# Access Compliance Report

## Public Rights-of-Way

### (Curb Ramps)

Intersection ID: N/A	Main Street: MARGIE_ANN_DR	Cross Street: ARLYN_CIR	Location: E
ADA ID: 7F0D16BD81B7	Ramp Type: Perp	Initial Pass/Fail: Fail	Overall Compliance: No
		Severity Score: 25

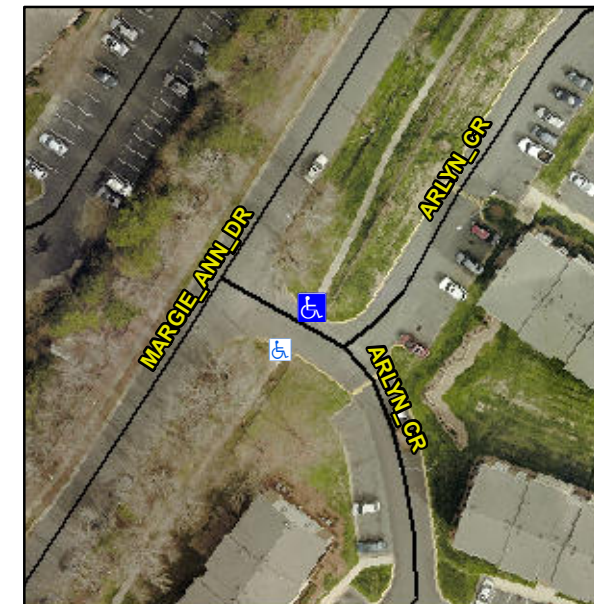
**Not Found, R304.2.2**

Compliance	Description	Data	Compliance	Description	Data
N/A	Ramp Length (in)	60.0	No	Ramp Slope (%)	15.1
Yes	Ramp Width (in)	48.0	Yes	Ramp XSlope (%)	0.5
N/A	Flare Type LT	N/A	N/A	Flare Type RT	N/A
N/A	Flare Slope LT (%)	N/A	N/A	Flare Slope RT (%)	N/A
N/A	Flare Traversable LT?	N/A	N/A	Flare Traversable RT?	N/A
N/A	Landing Length (in)	N/A	N/A	DWS Provided?	N/A
N/A	Landing Width (in)	N/A	N/A	DWS Contrast?	N/A
N/A	Landing Slope (%)	N/A	N/A	DWS Length (in)	N/A
N/A	Landing X Slope (%)	N/A	N/A	DWS Full Width?	N/A
N/A	Landing Curb? (Y/N)	N/A	N/A	DWS Offset (in)	N/A
N/A	Shared Landing?	N/A			
N/A	Gutter Ponding?	N/A	N/A	Gutter Slope (%)	N/A
N/A	Gutter Lip Ht (in)	N/A	N/A	Gutter X Slope (%)	N/A
N/A	Painted X Walk1?	No	N/A	Painted X Walk2?	N/A
	X Walk 1 Direction	To SW		X Walk 2 Direction	N/A
N/A	X Walk 1 Width (in)	N/A	N/A	X Walk 2 Width (in)	N/A
	X Walk 1 Slope (%)	0.6		X Walk 2 Slope (%)	N/A
	X Walk 1 X Slope (%)	2.5		X Walk 2 X Slope (%)	N/A

**Remove & Replace Entire Ramp.**
